5. Lease Serial No.  
NMNM27506
6. If Indian, Allottee or Tribe Name
7. If Unit or CA/Agreement, Name and/or No.
8. Well Name and No.  
SALADO DRAW 29 26 33 FED COM 1H ✓
9. API Well No.  
30-025-42629 ✓
10. Field and Pool, or Exploratory  
WILDCAT BONE SPRING
11. County or Parish, and State  
LEA COUNTY, NM

**Salado Draw 29 26 33 Fed Com 1H  
API 30-025-42629  
Chevron USA Incorporated  
Conditions of Approval**

# Delaware Basin Changes to APD for Federal Well

## Summary of Changes to APD Submission

### Salado Draw 29-1H Drilling Program "Quick-Look"

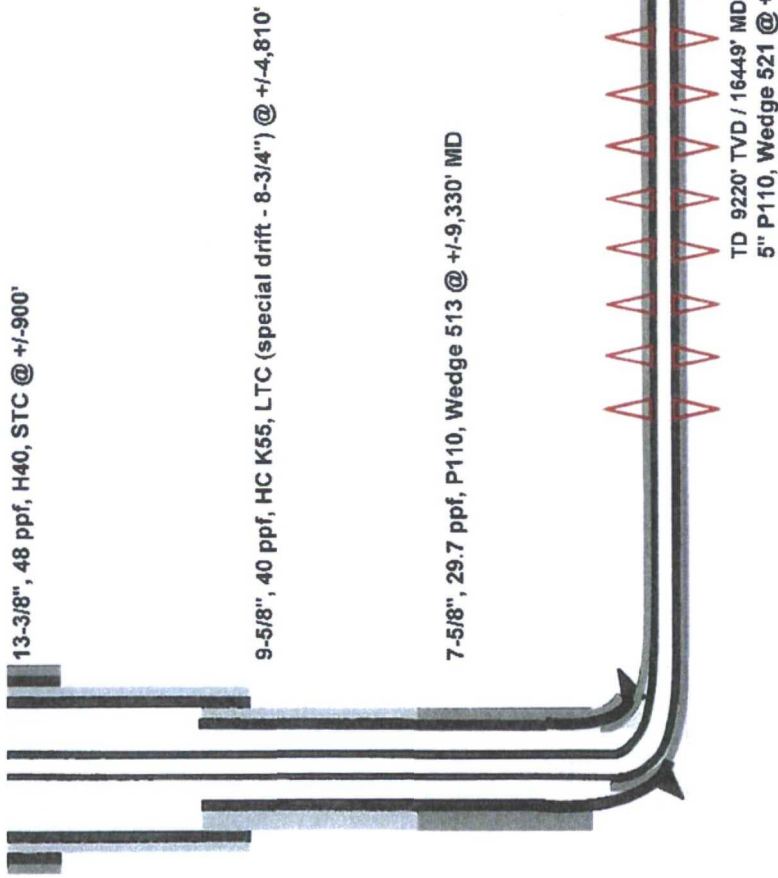
**Summary:** Chevron respectfully requests to a drilling change for the lateral from a 8-3/4" hole section to a 6-3/4" hole section. A 5" casing will be ran in the lateral section and will comply with the .422 casing clearance; which original plan was 5-1/2". This is due to the contingency string that was ran to cover up the water flow that was observed.

Original plan was to drill a three hole section wellbore, and will not be changed to a 4 hole section string.
